Case Ref: Planning Application ABP-PAX 92.324279

Ballincor Wind Farm, Counties Offaly and Tipperary

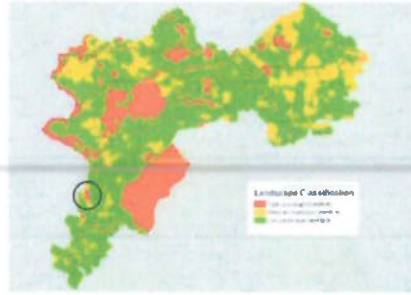
The Applicant erroneously identifies the area as designated in the *"Moderate and Low Sensitivity"* classification category (Ch12 page 24). The Council's own Landscape Sensitivity Map, reproduced above, does not support that characterisation. The area around Sharavogue Bog is classified Red — High sensitivity — and the broader landscape east of the site, where this property and the homes of our neighbours stand, is classified High to Moderate. The Applicant's own documents acknowledge that the site boundary is, in places, ten metres from Sharavogue Bog and that the River Brosna forms a substantial part of the site perimeter.

Offaly County Council has not granted High sensitivity status lightly. The Sharavogue Bog landscape is the one small area, for miles in every direction, that carries that designation. The Applicant's Landscape and Visual Impact Assessment is built from a starting position — "Moderate and Low" — that the Council's own published mapping contradicts. The Applicants full Visual Impact assessment deliberately starts from the wrong place.

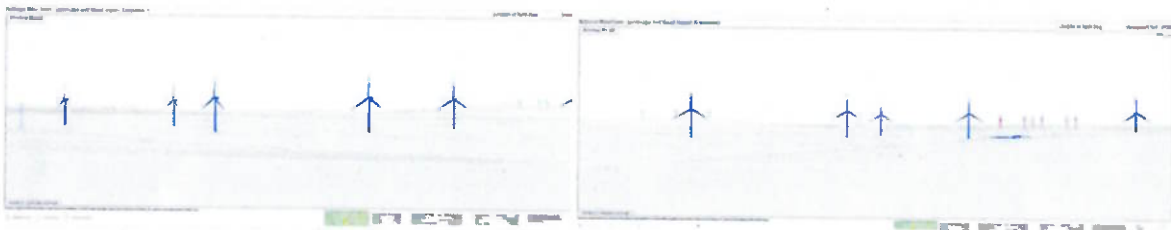
When you put the RWE/LVIA Wireframes side by side for this Vantage point you capture the full scale of our view. All 11 Ballincor in blue, the 8 of Lacka/Skehanagh in grey on the horizon and to the right the 7 of Carrig in red.

RWE concludes their analysis with *"No significant visual effects at any of the 27 VRPs. Only one viewpoint (VP20, at 1 km) reaches the borderline-significant "Substantial-moderate" threshold, with three more at "Moderate" – all within ~2 km of the nearest turbine."*

The images above tell a different story. Eleven turbines, each up to 180 metres in tip height, are strung in a continuous line across the entire visible skyline — not clustered, not overlapped, not contained within a defined envelope, but extended across the full width of the available view. Behind them, the 8 turbines of the operational Lacka/Skehanagh wind farm (less than 3 km away) and the 7 permitted turbines of Carrig (less than 4 km to the north) compound the effect. From my home, and from those of my neighbours, this is not a "working rural landscape" with occasional wind energy precedent, as the LVIA characterises it. It is a landscape on the verge of being defined, dominated, and visually consumed by industrial-scale wind energy development. The Applicant's own conclusion at VP20 — that the turbines will be "dominant but not overbearing" — is contradicted by the photomontage evidence and by the lived experience of residents who will see this development from every window facing the site. The only references in the entire LVIA to the cumulative presence of the 8 Lacka turbines and the 7 Carrig turbines dismiss them as "modest scale developments" that "will not become a landscape that is defined by wind energy development." That conclusion is not credible when 26 turbines (11 proposed + 8 + 7) will be visible in combination or close succession from receptors within a few kilometres of the site.
